Planning Application Ref: EG/10/18/DOC

Location: 59 Elm Grove, Barnham

Description of works: Application for Discharge of Condition 7 (EG/41/17/PL)

Comments on Application:

Fig.2 – View N across site entrance towards TPF intended for T08 (removed).

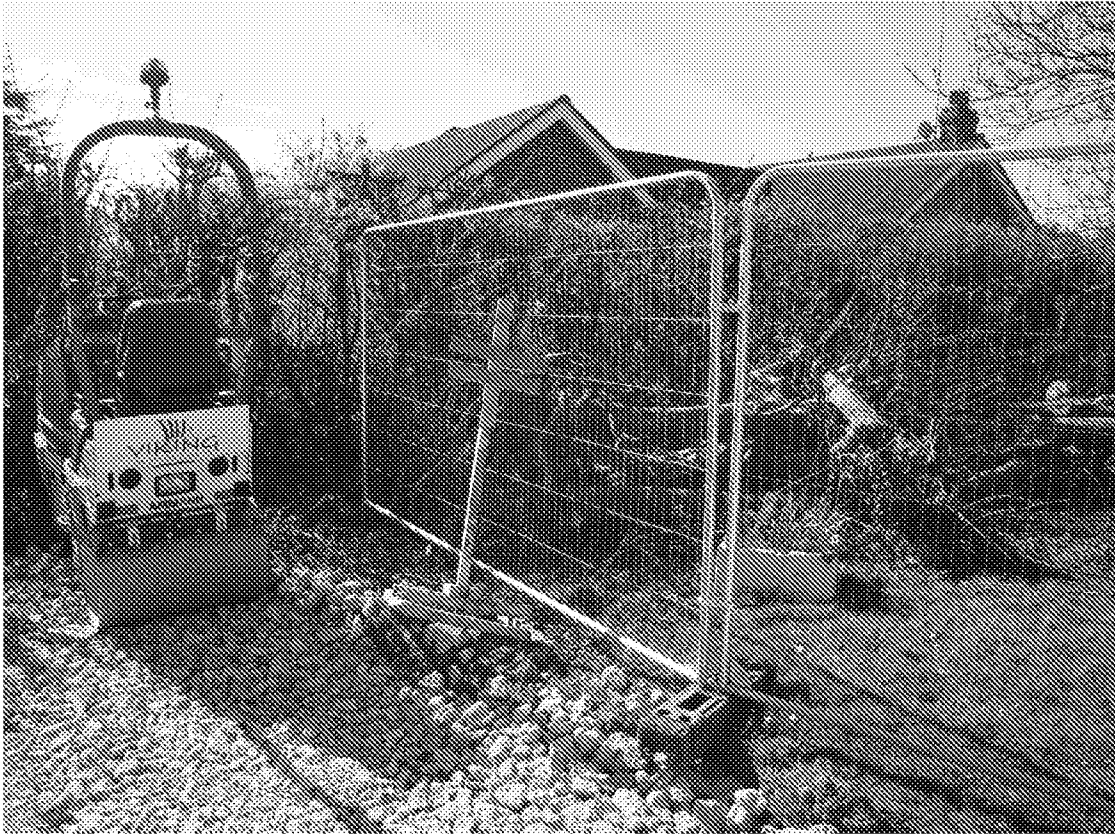
• Tree nos T01, T03 and T08 and mixed species hedgerow around the site entrance have been removed, despite their being identified for retention. Numerous other trees previously identified for removal have been so, thus there is no significant vegetation around this section of the site frontage. This now negates any requirement for the proposed ‘No dig’ construction North of T1 and installation of Tree Protective Fencing (TPF) around the Root Protection Area (RPA) of T08 as detailed on the plan (figs.1 & 2).
